Sub: Power supply and MCB of FSDS System.

Ref: PS & EMU Directorate letter no. EL/6.8.21 dated 15.07.2024 (copy enclosed).

Sub: Guidelines for continuous power supply to fire and smoke Detection System (FSDS) shall be provided from terminal Block (TB) X1 of Switch Board Cabinet (SBC).

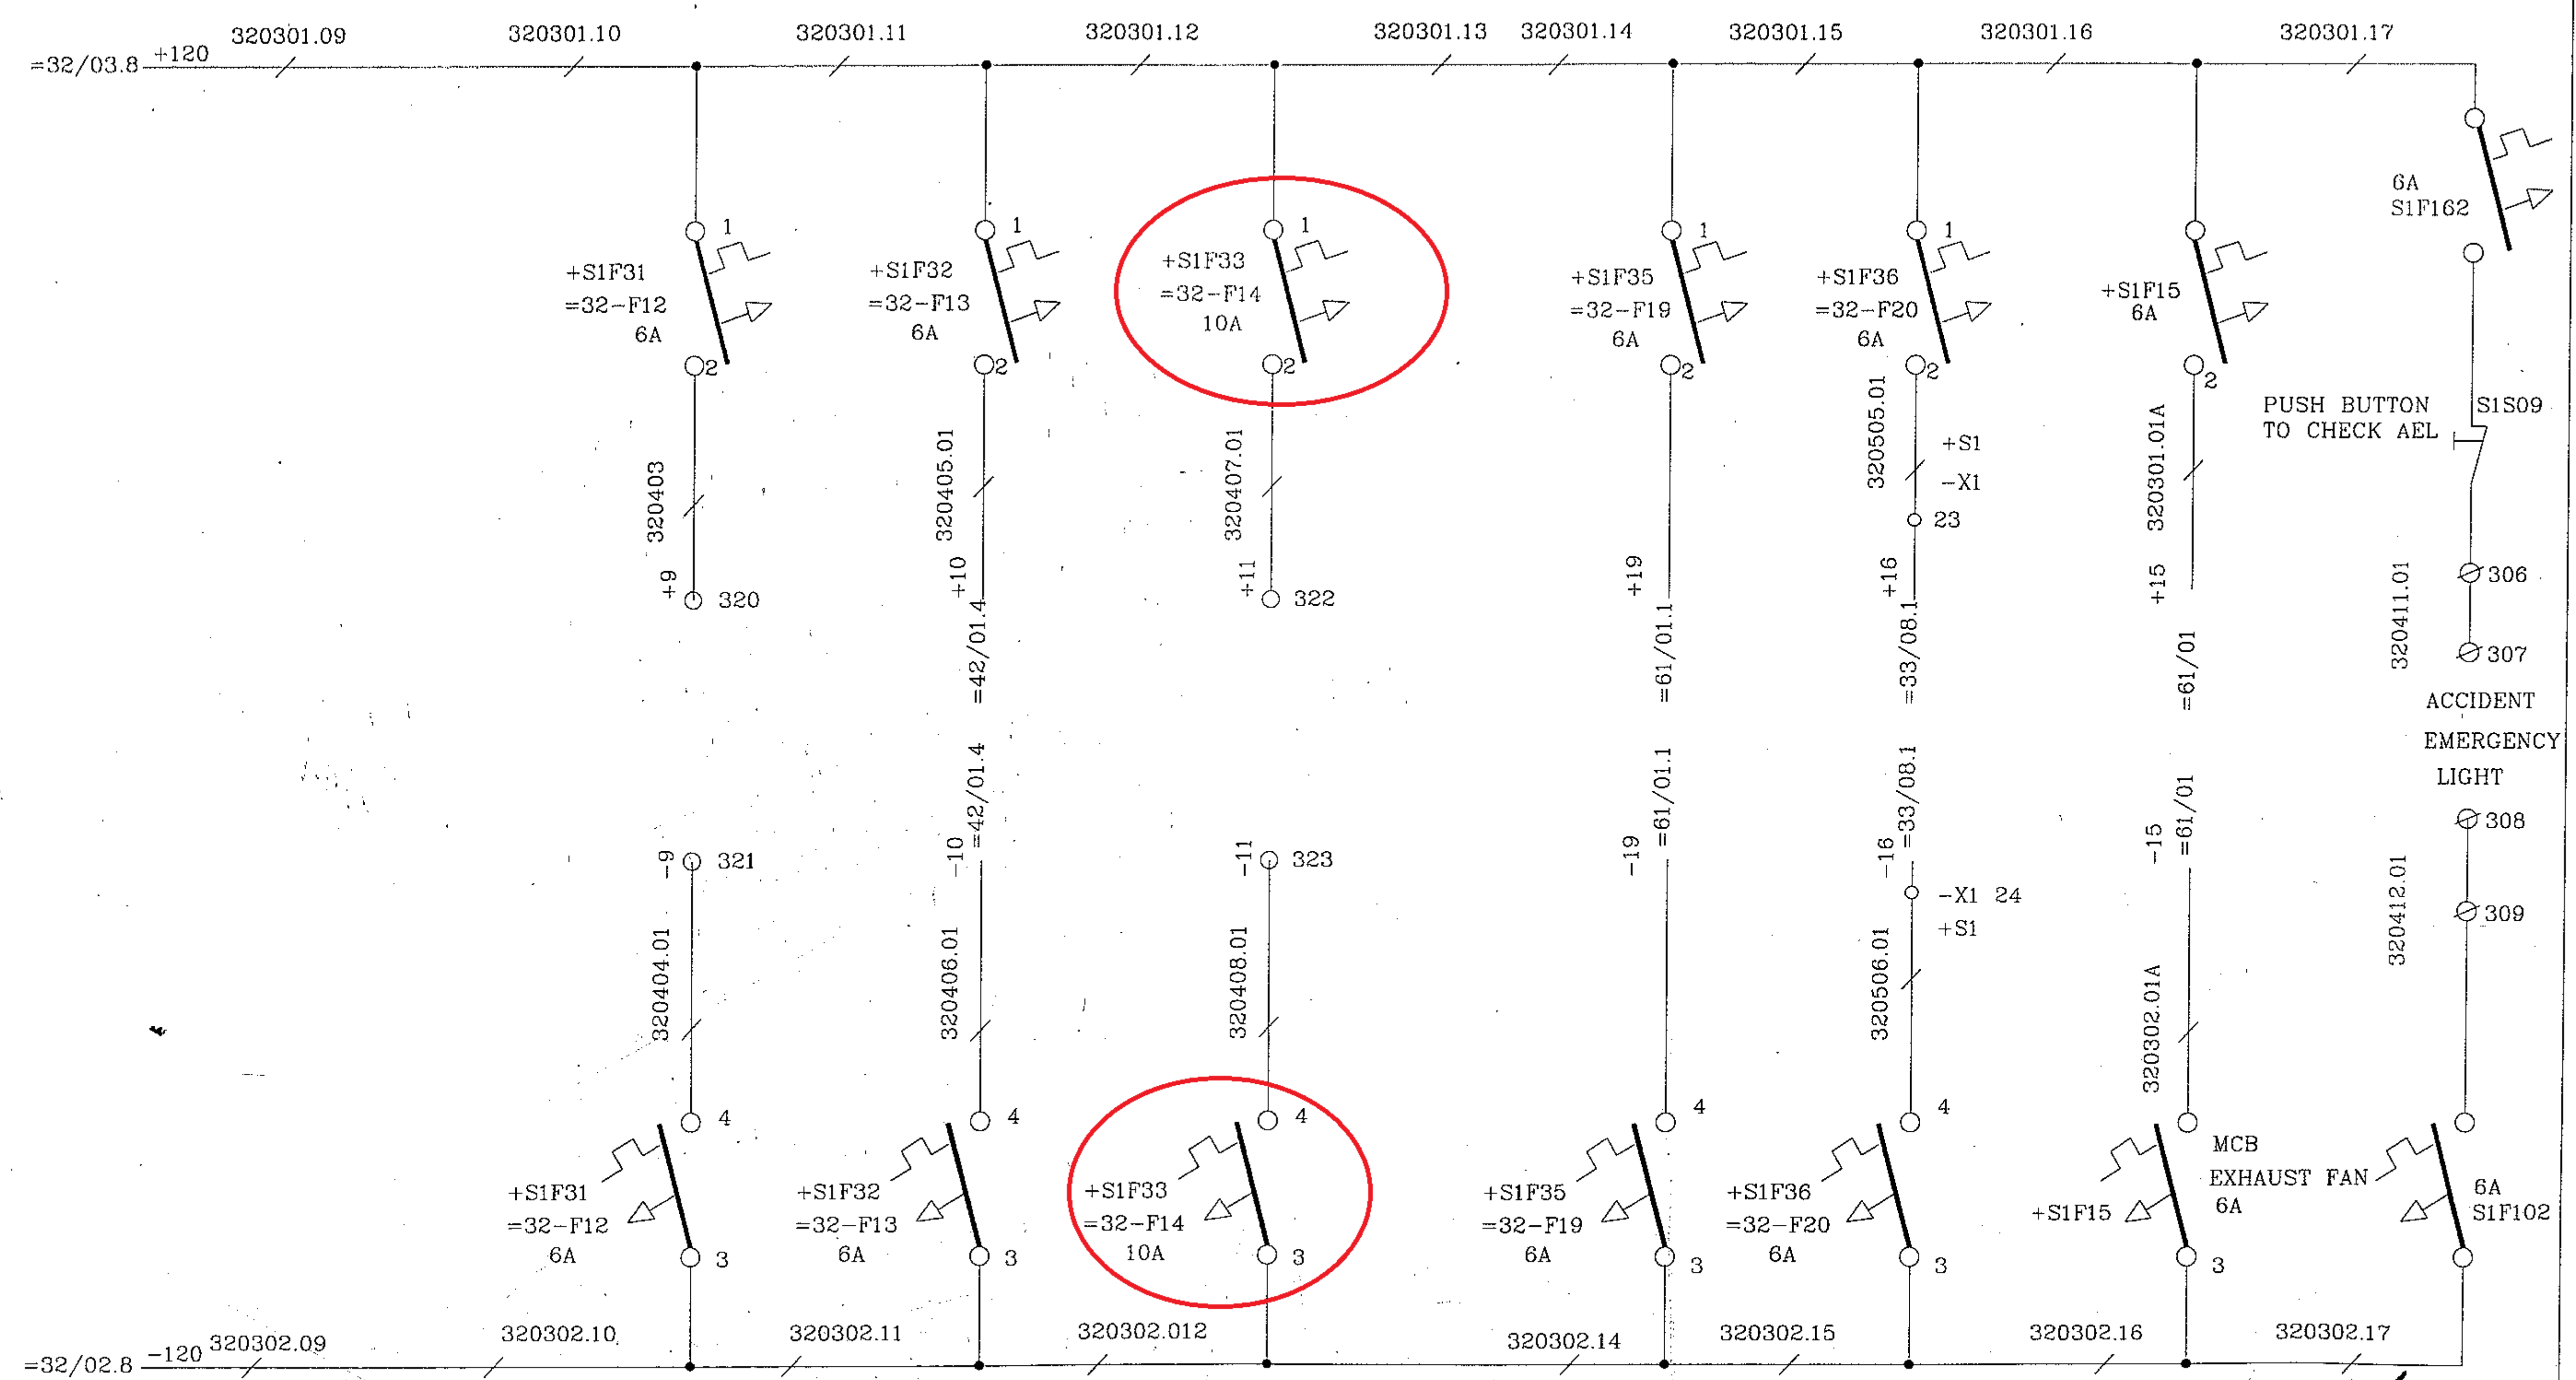
S. No.	Type of Coach	Place of Installation
i	LHB variant of AC coaches.	Supply may be taken from the place of installation of MCB S1F33 with 2A, 2P, C-curve, 110V DC MCB. The indication of MCB in Sheet no. 11 of 48 of RDSO drawing no. RDSO/PE/SK/AC/0206-2019 (Rev.0) attached as ANNEXURE A
ii	ICF type SG AC coaches	Dedicated 2A, 2P, C-curve 110V DC MCB to be provided after the common 40A DC MCB as shown in RCF drawing no. CC70401 (Copy enclosed). The MCB to be placed in The Power Panel besides other DC MCBs. New 2A MCB provided to be marked as FSDS. The indicated drawing is attached as ANNEXURE B
